# Measuring $RIN_{xx}$ OMA using an Oscilloscope

IEEE 802.3 Interim Meeting – 802.3dj D1.2 Comment Resolution  
Hamburg, Germany

# RIN<sub>xx</sub>OMA - IEEE 802.3dj – Draft 1.1 - Clause 180.9.11

# Measuring RIN<sub>xx</sub>OMA using an Oscilloscope – IEEE 802.3 Method

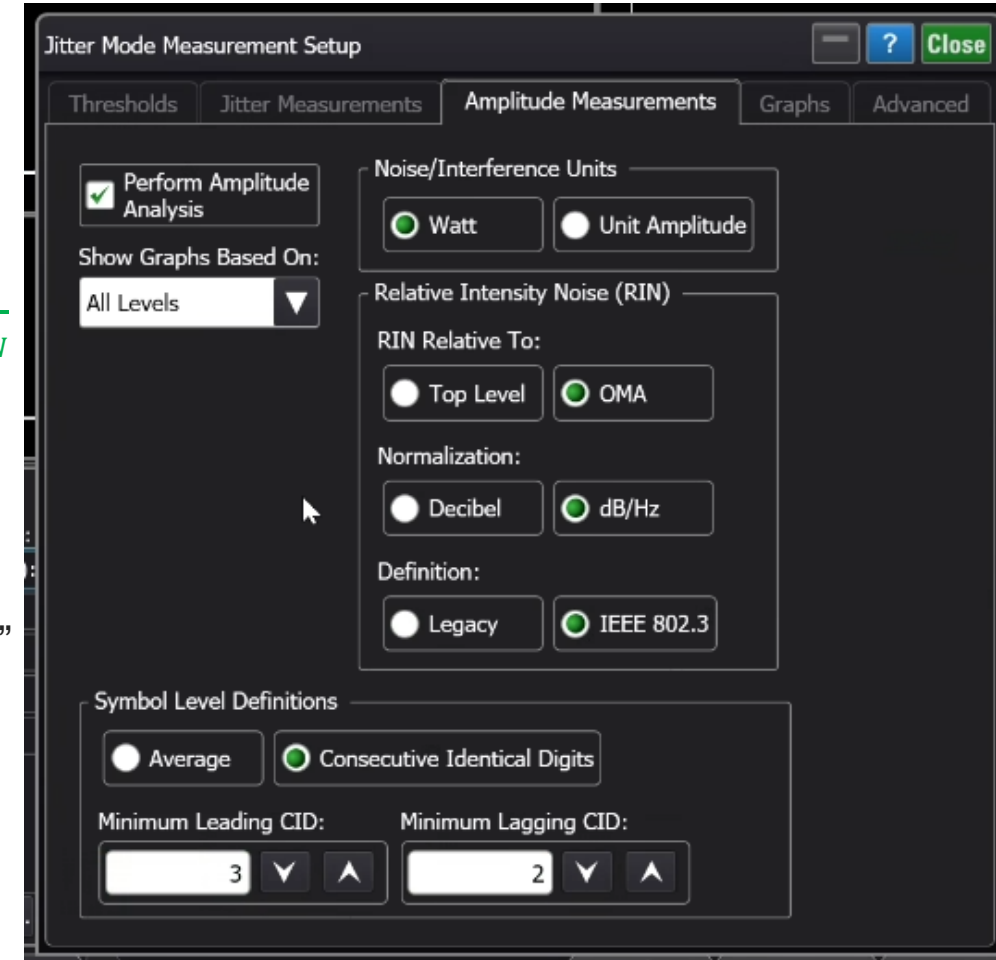
➤ This is what is currently implemented in FlexDCA when the “IEEE 802.3” method is selected

➤ This is a factor of 4 different than the current definition of RIN<sub>xx</sub>OMA in 802.3dj draft 1.1 (also legacy method)

➤ Therefore; RIN<sub>xx</sub>OMA can be defined as:

$$RIN_{xx}OMA = 10 \log_{10} \frac{(RN_3 + RN_0)^2}{OMA_{outer}^2 \times BW_N} \text{ (dB/Hz)}$$

# Measuring RIN<sub>xx</sub>OMA using an Oscilloscope – Comment Method

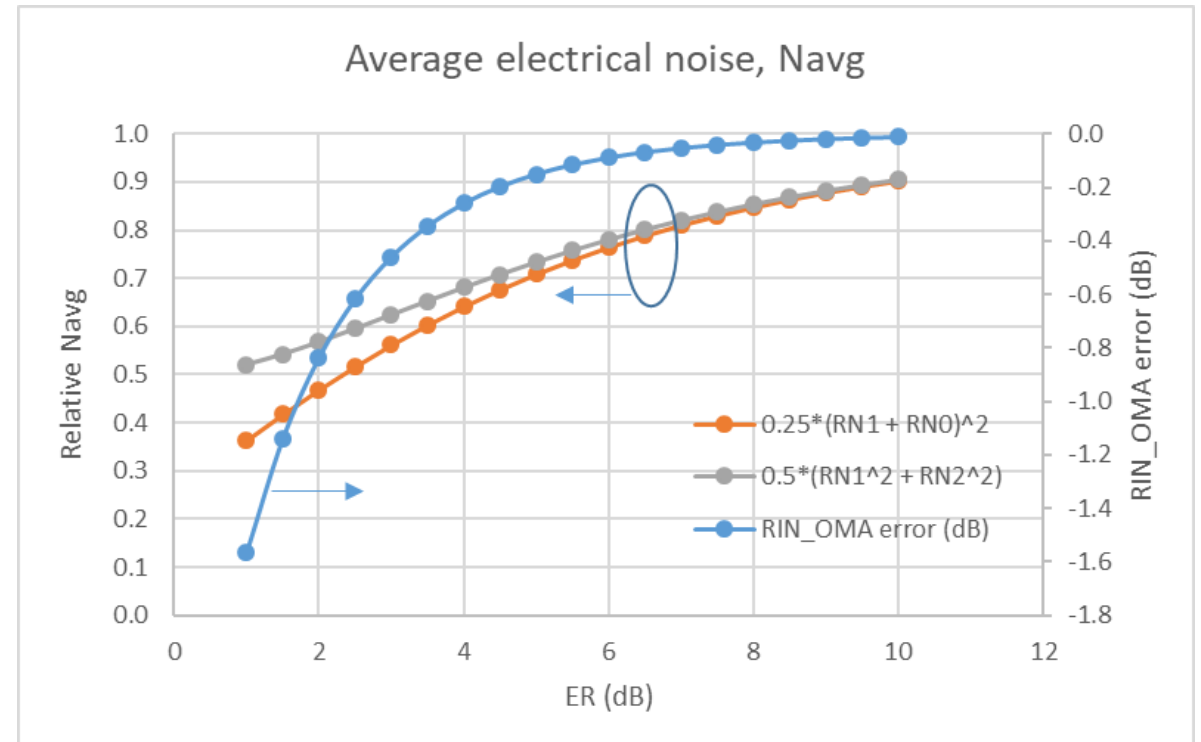
- Using the RSS average of optical noise is an acceptable approach
- This approach does not match the original RIN<sub>xx</sub>OMA measuring P<sub>N</sub> on an unmodulated signal
- If the electrical noise power is defined as an RSS average of noise, then:

- Therefore, RIN<sub>xx</sub>OMA is a factor of 4 different from the proposed definition in comment #408

Cl 180	SC 180.9.11	P392	L 37	# 408
Ran, Adee		Cisco Systems, Inc.		
Comment Type	TR	Comment Status	X	
Equation 180-1 sums N0 and N3 and then squares them and divides by 4 - this seems inadequate. RIN should be a power ratio, so two measured noise levels should be power-averaged, not linearly averaged and then squared.				
Also in other optical clauses.				
SuggestedRemedy				
Change the denominator from (N0+N3)^2/4 to (N3^2+N0^2)/2.				
Apply in other optical PMD clauses.				
Proposed Response	Response Status O

- The  $RIN_{xx}OMA$  definition is dependent on the interpretation of the electrical noise power ( $P_N$ )
- Both definitions (averaging and RSS averaging  $RN_3$  and  $RN_0$ ) will lead to a very similar  $RIN_{xx}OMA$  value at the OER range of IEEE 802.3dj ( $> 3.5\text{dB}$ )
- The current definition, using  $(RN_3 + RN_0)/2$  to calculate the electrical noise power, is a closer match to the original definition of  $P_N$  in IEEE Std 802.3ae<sup>TM</sup> - 2002
- Using an RSS average is also an acceptable approach; however, it does not match the historic  $RIN_{xx}OMA$  measurement used for many years now
- We recommend sticking to the current definition and dropping the /4 factor from the current draft
- Therefore;  $RIN_{xx}OMA$  should be defined as:

$$RIN_{xx}OMA = 10 \log_{10} \frac{(RN_3 + RN_0)^2}{OMA_{outer}^2 \times BW_N} \text{ (dB/Hz)}$$
